Queensland Competition
Authority
FINAL

**AURIZON NETWORK
REVIEW OF BALLAST
UNDERCUTTING
SCOPE AND COSTS**

20 NOVEMBER 2015

Figure 6 Aurizon Network's process for developing ballast undercutting scope and schedule of works

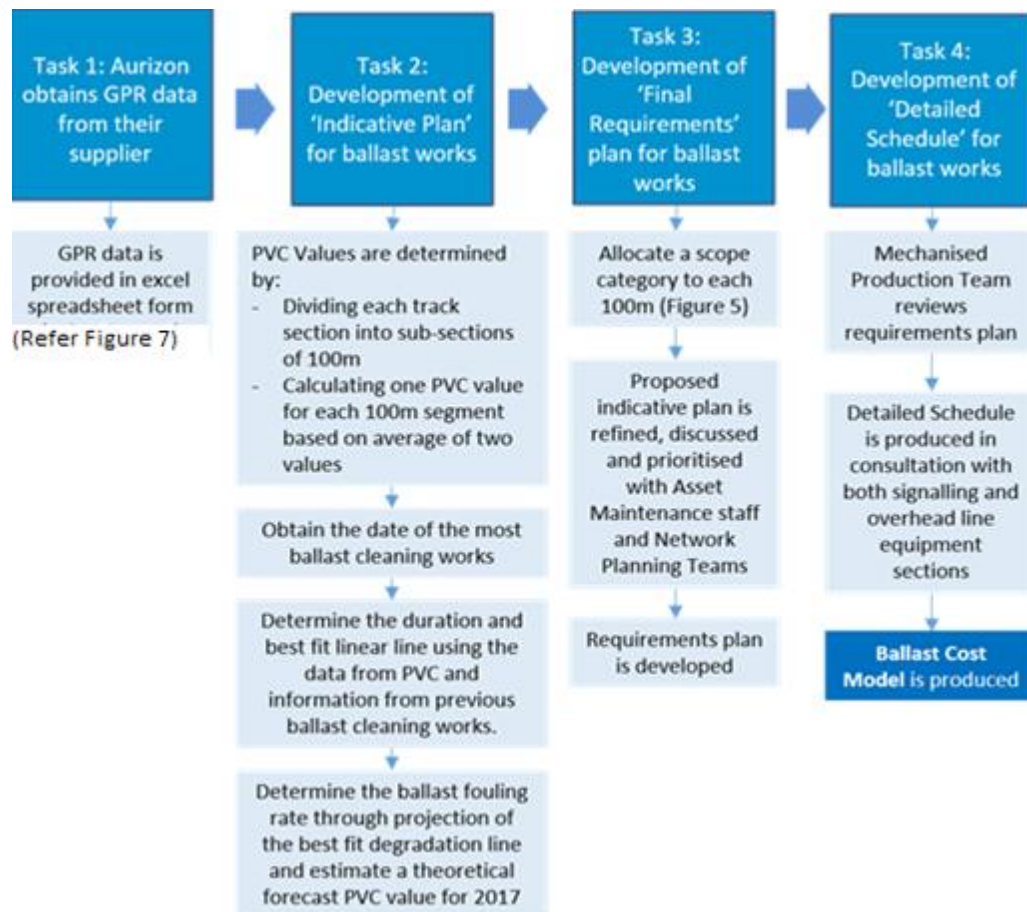
Although the Review Team considers the use of the two figures will add rigour to the projection estimate, it is noted where a negative figure was obtained from the accumulation of the FY2012 and FY2014 figures (that is, where the PVC value had decreased between those two years), the FY2012 figures are excluded.

In addition, if the FY2012 data is missing and there are no records of previous undercutting, the FY2017 forecast value is set to be equal to the FY2014 PVC value. Effectively, this approach assumes the PVC does not change for the track segment and there will be zero PVC growth.

- The methodology does not take into account tonnage wear. It is reasonable to expect that the wear over the period is combined with tonnages to provide the unit fouling rate per year per Mnt of rail traffic.
- No acknowledgement is made of other works which may impact the condition, only previous undercutting works – although Aurizon Network stated these works were likely to be the reason for any recorded PVC “improvements”. The Review Team considers it important to record and highlight where such works did take place (and where they did not). Where there are still high instances of such differences occurring, this process will reveal potential issues with calibration (or other matters).
- No allowance is made for expected decreases in fouling rates due to initiatives such as the coal veneering program.

The omission of these factors raises questions in relation to the robustness of the forecasted rate of degradation.

Figure 11 Change in PVC from 2012 to 2014 no ballast undercutting works after 2012 (n=10,105, all rail systems)

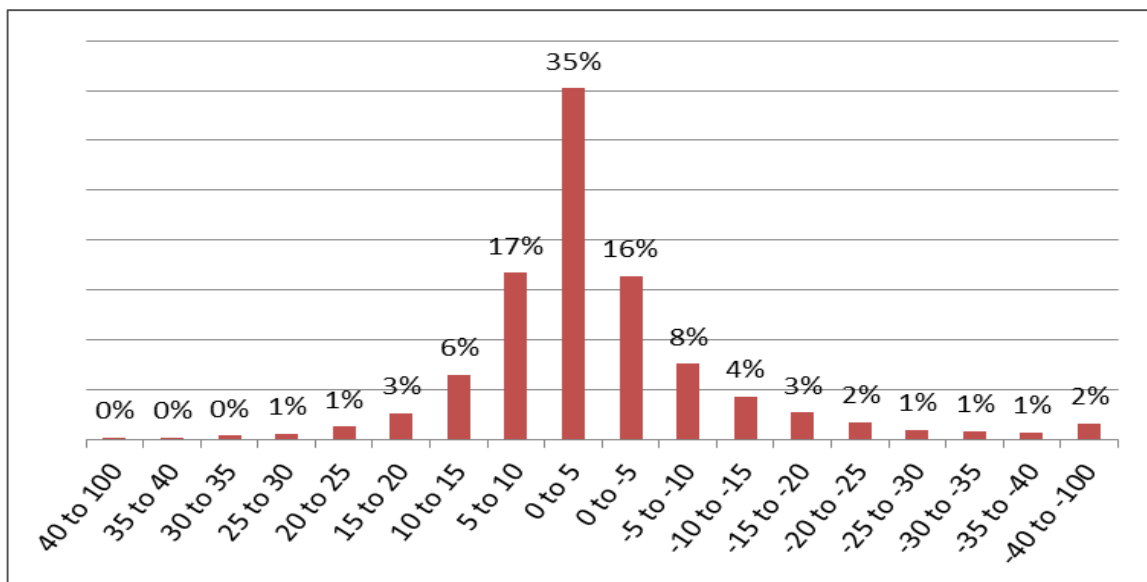
- 333.8km (3338 sections of 100m track) or 37 per cent of the total number of 100m lengths has a PVC value that has fallen from 2012 to 2014; and
- 115.3km (1153 sections of 100m track) or 13 per cent had a PVC value fall by greater than 10 percentage PVC points (Figure 11).

The results from Figure 11 demonstrate the importance of taking into account all reparation and other maintenance works which may any impact on the resultant projection of ballast degradation. It is apparent that these works potentially have a significant effect on the GPR result and subsequently may skew the resultant projection for the development of the ballast undercutting scope.

Figure 13 Change in PVC from 2012 – 2014; with ballast undercutting works between 2012 and 2014 (n=1866, all rail systems)

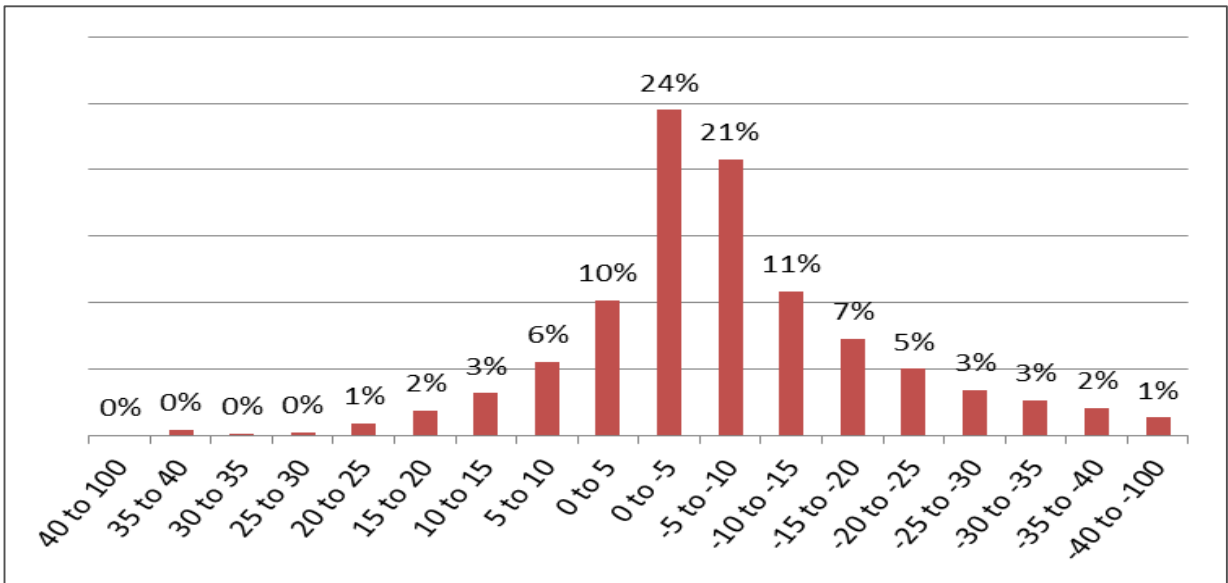
For those segments of track that have had works undertaken since 2012, The Review Team found that approximately 257km of track (28 per cent of the total number of 100m lengths) had a PVC value that has increased from 2012 to 2014 (Figure 13). This is an unexpected result as if works have been undertaken on a segment of track it seems counter-intuitive that there would be a subsequent increase in the PVC value.

Figure 14 Comparison of PVC values for 2012 and 2014 with ballast undercutting works after 2012 for a section Goonyella track (n=30)

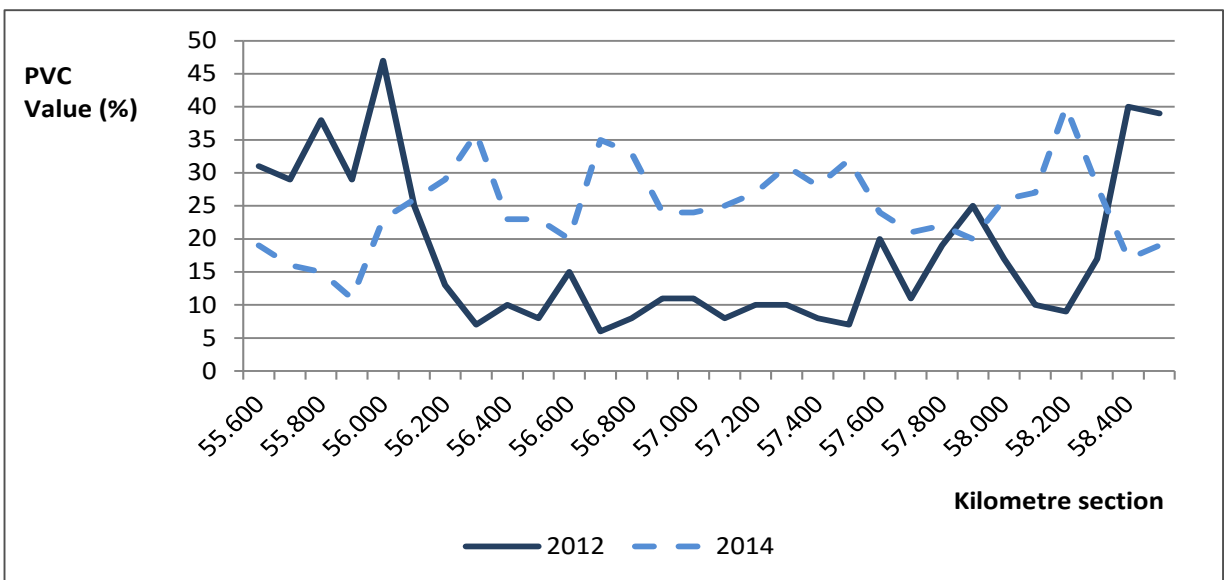
An example of this issue is illustrated in Figure 14 for a 3km section of Goonyella track. This shows that, from the data provided for review for ballast undercutting works, there are a number of 100m segments where the PVC values are, and in some cases significantly, greater in 2014 than in 2012 and yet work was undertaken on these segments between 2012 and 2014.

The Review Team has used 2012 GPR data to verify the 2012 PVC data. This analysis confirmed the 2012 PVC values for the 3km section of Goonyella track. As such, the Review Team believes there are a number of possible sources of these unexpected results:

Figure 25 Ballast scope kilometres with different PVC threshold levels

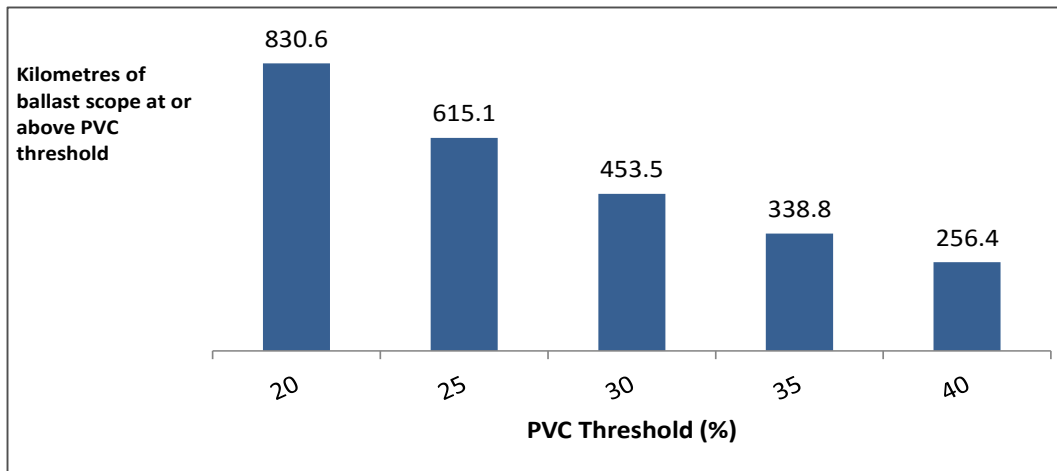
It is noted that ballast scope and overall scope costs are very sensitive to changes in the PVC threshold (Figure 25). A key issue for ballast scope planning works, and to potentially mitigate the liability risks associated with operational risks, is that it may be best, on a risk and benefit-cost basis, to focus first on those sections of track that have the highest PVC levels. Under Aurizon Network’s current approach there is no further categorisation of those sections of track that are over the 30 per cent PVC threshold. However, it may more optimal to place a higher priority on the 256 kilometres of track with PVC values greater than 40 per cent compared to those in the 30 to 40 per cent range. Aurizon Network should consider applying this type of approach in conjunction with appropriate risk and high level benefit-cost considerations.
